# SERVICE LETTER

No. 935

Piper Aircraft Corporation

ELT Antenna Inspection

NARCO ELT - 10  
CABLE CONNECTOR AND CONTACT  
SEPARATOR

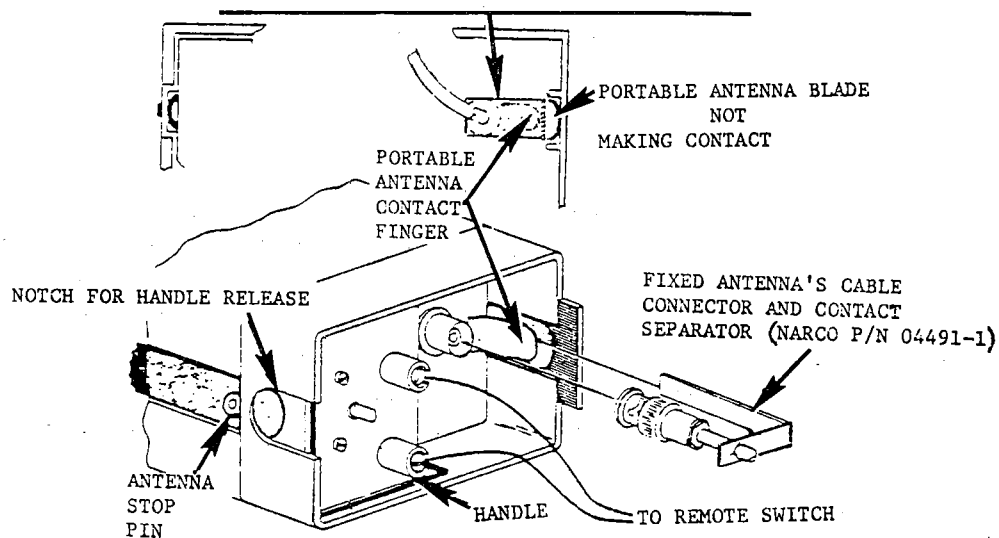
Service reports received from the field indicate the possible absence of the ELT fixed antenna's contact separator. If this separator is not installed between the portable antenna contact finger and antenna blade, both antennas could be connected, degrading the performance of the ELT and causing a reduction of signal range.

1. Gain access to the ELT unit.
2. Insure that the coax cable connector is locked in position on ELT unit.
3. Insure contact separator Narco Part No. 04491-1 is properly installed (reference attached sketch).
4. If contact separator is not installed or if replacement is required, install Nacro Part No. 04491-1 Contact Separator, as shown on attached sketch.
5. After inspection of coax connector and contact separator, secure area of ELT unit.
6. Make appropriate logbook entry indicating compliance with this Service Release.

CONTACT SEPARATOR INSTALLED  
BETWEEN CONTACT FINGER AND  
PORTABLE ANTENNA BLADE
